FROM: Maserati TSO

## Rapid Update 695 Grecale – Steering wheel switch noise

DATE: DECEMBER 18 2023

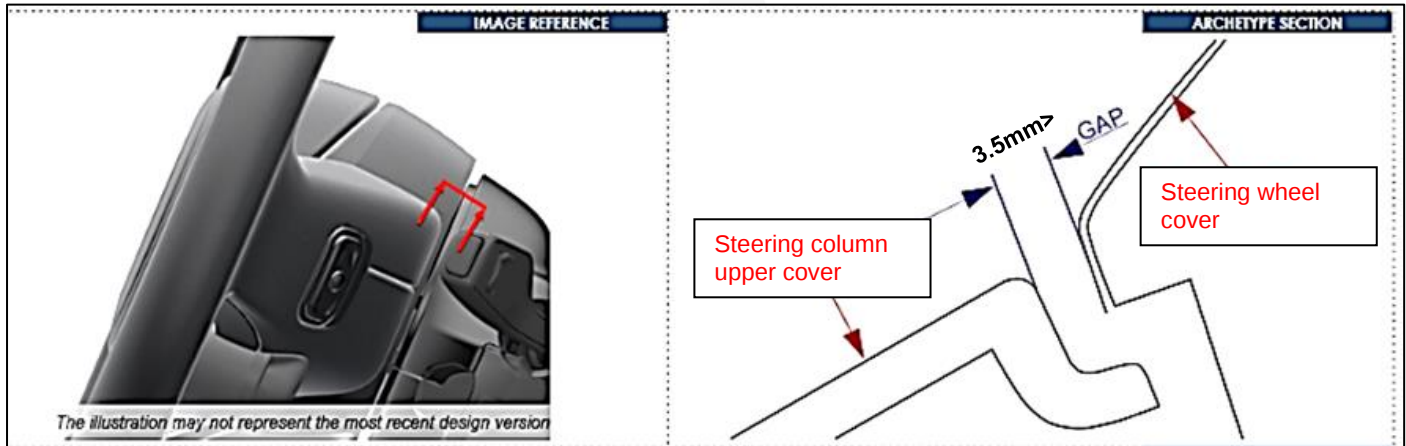
In some vehicles, Steering column assemblies may have been installed without the required gap between the steering wheel vs the "switch cover" (also referred to as the clamshell). This interference doesn't impact the force required to operate the steering wheel, nor does it affect or hinder its functionality in any manner. However, it results in a rustling noise that may be perceived as annoying. The procedure entails a verification check and potential replacement of the entire steering column.

1. Always check ModisCS+ to see if the vehicle is involved in this action and if it has not been previously performed.
2. First, **rotate the steering wheel lock to lock at least 5 times** completing the entire turn, both all the way to the right and to the left to check that there are no excessive sliding noises.
3. Inspect the gap clearance between the steering wheel cover and the column cover as illustrated in the photos below visually and using a measurement tool (e.g. Digital caliper).

- **OK** ► gap is **greater than 3.5 mm**> the component is **OK**. No further action is needed. Release the vehicle.
- **NOT OK** ► gap is **less than 3.5 mm**< or even absent (see above photo). Replace the Complete Steering Column following the instructions in the workshop manual:
  - Section 05.00 – 1 (05.00.001 COMPLETE STEERING COLUMN - Removal-Refitting or Replacement)
